### APPEAL SUMMARY

<b>Appeal ID:</b> 18973	<b>Project Address:</b> 920 SW 6th Ave
<b>Hearing Date:</b> 2/6/19	<b>Appellant Name:</b> Tom Jaleski
<b>Case No.:</b> B-025	<b>Appellant Phone:</b> 503-488-5651
<b>Appeal Type:</b> Building	<b>Plans Examiner/Inspector:</b> Jeffrey Rago
<b>Project Type:</b> commercial	<b>Stories:</b> 15 <b>Occupancy:</b> A-3, B <b>Construction Type:</b> I-A
<b>Building/Business Name:</b> P+L Building	<b>Fire Sprinklers:</b> Yes - Throughout
<b>Appeal Involves:</b> Alteration of an existing structure	<b>LUR or Permit Application No.:</b>
<b>Plan Submitted Option:</b> pdf [File 1] [File 2] [File 3] [File 4]	<b>Proposed use:</b> Office Building

## P+L Building Occupant Load Calculations for Title 24.85

SHEET NUMBER:  
**A0.21.1**

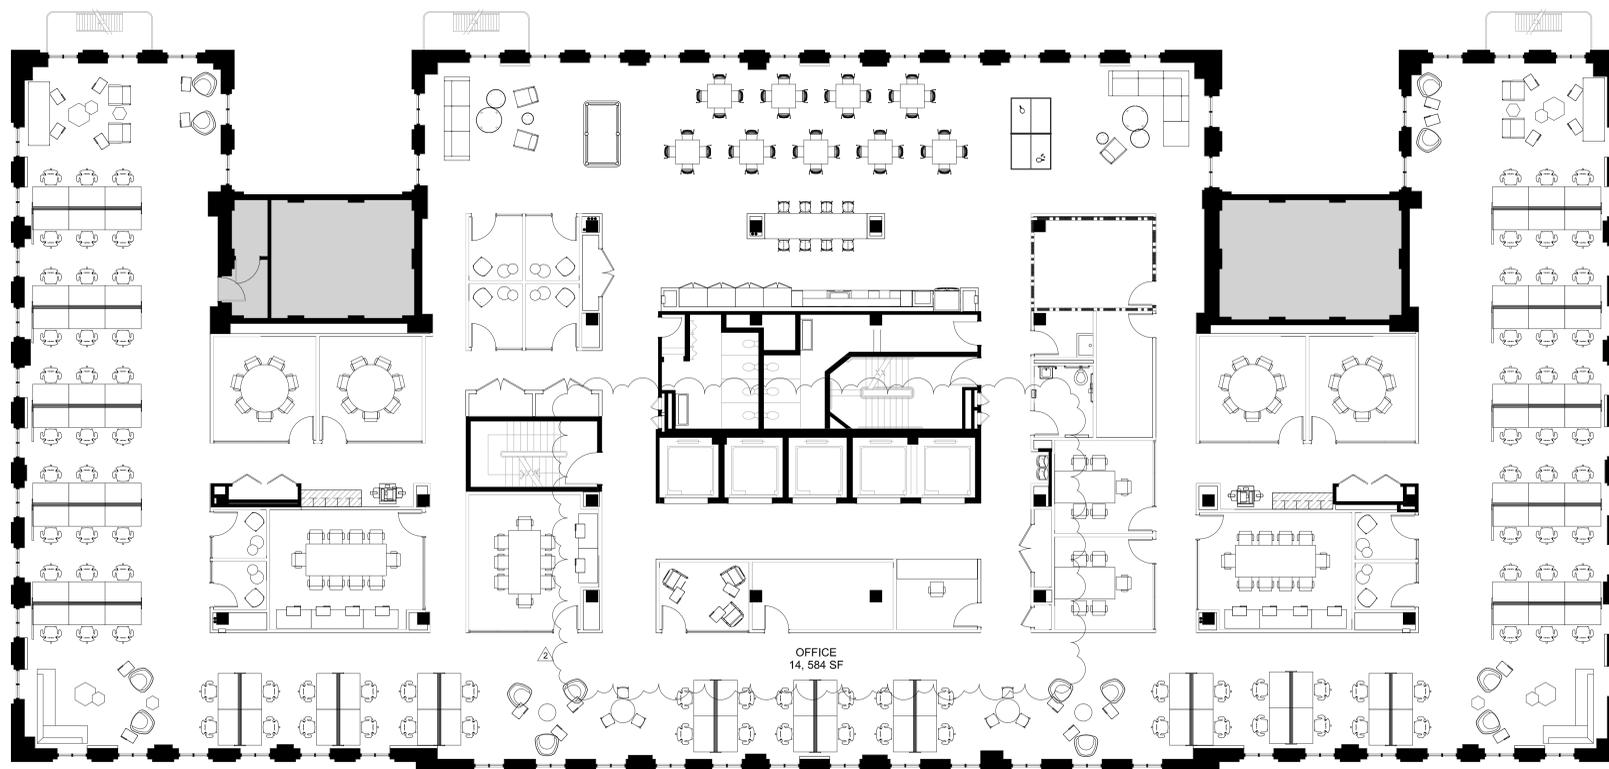
<b>Proposed Design</b>	<p>Coinbase, the tenant leasing the 7th and 8th floors, has changed their proposed design from what was previously approved in appeal #18160. This appeal new is intended to supersede the prior appeal.</p> <p>Appeal #18160 granted a reduction in 7th and 8th floor calculated occupant load for Title 24.85 based on actual number of occupants and non-simultaneous use. The 7th floor was approved for 174 occupants, and the 8th floor was approved for 181 occupants, 355 between the two floors. The proposal is to maintain the 355-occupant load across the two floors for Title 24.85 based on the following:</p> <ul style="list-style-type: none"> <li>• Life safety systems will be based on the occupant loads for each space as determined per Table 1004.1.2.</li> <li>• 7th floor: The publicly accessed reception lobby has been eliminated. There is no public access</li> </ul>

to the 7th floor. Elevator access to the floor is locked and accessed only by card reader, for employees and escorted guests only. Public reception for the tenant is solely on the 8th floor.

- 8th floor: The central reception lobby has increased in size by 48 sf from 616 sf to 664 sf. All doors from the reception lobby into the tenant space will be locked and accessed only by card reader, for employees and escorted guests only.
- An agreement between the building owner and Coinbase limits the occupant load of the two floors to 355 for Title 24.85 based on appeal #18160.
- The security for the floors will be managed by the Coinbase Security Systems Team to monitor and check each person's entry into the space.

- 7th floor: 172 occupants
- 8th floor: 183 occupants
- 355 occupants total between both floors.

**1. Reduction in seventh floor calculated occupant load to avoid seismic upgrades based on actual number of occupants and non-simultaneous use: Granted as proposed for this tenant and use only.**
